# United States Patent and Trademark Office

This is the **Final Office Action** for application number 10/626,110 Steadying Support Platform, filed on 7/23/04. Claims 1-21 are pending. Claims 9-21 are withdrawn. This **Final Office Action** is in response to applicant's reply dated 10/30/06. The text of those sections of Title 35, U.S. Code not included in this action can be found in a prior Office action.

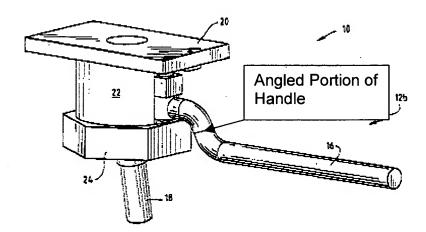
The patent to Reese et al. discloses a camera steady device (10) having a support platform (20) and a support shaft (16a, 18) connected to the bottom surface of the platform, having a first upper portion (16), and a separate second lower portion (18), the first and second shafts being positionable within 60 degrees relative to each other and a locking mechanism (24) to lock them in place, a sphere (30) affixed to the upper portion of the support shaft (16a, 18) a socket with a handle (32a, 32b, 16) which has a

straight portion and an fifteen degree angled portion (See Drawing Below), the socket which is permitted to freely pivot about the sphere, a range of plus or minus 60 degrees about a roll and pitch axis and plus or minus 360 degrees about a yaw axis by being, the socket which has a first upper plate (32b) with a first downwardly directed truncated spherical recess and a second lower plate (32a) with a second upwardly directed truncated spherical recess, the recesses which pivotally captures the sphere (30).
